Technical Bulletin No. RTB-001

SUBJECT: Condor Manual Correction	DATE: May 31, '96 PAGE: 1 of 2
PREPARED BY: M. Ishihara CHECKED BY: T. Inoue	FROM: 1st Field Information Dept. QAC

MODEL: Condor

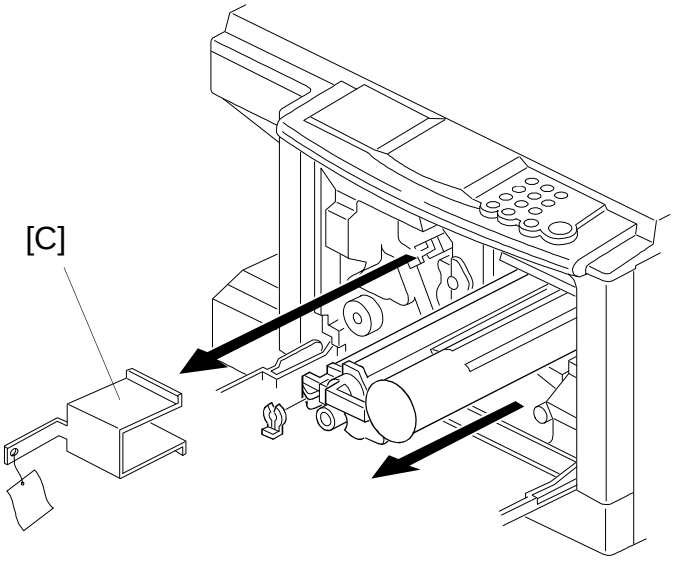
2. Please add the following step between steps 2 and 3 of the installation procedure (page 3-5).

Remove the cleaning blade clamp [C].
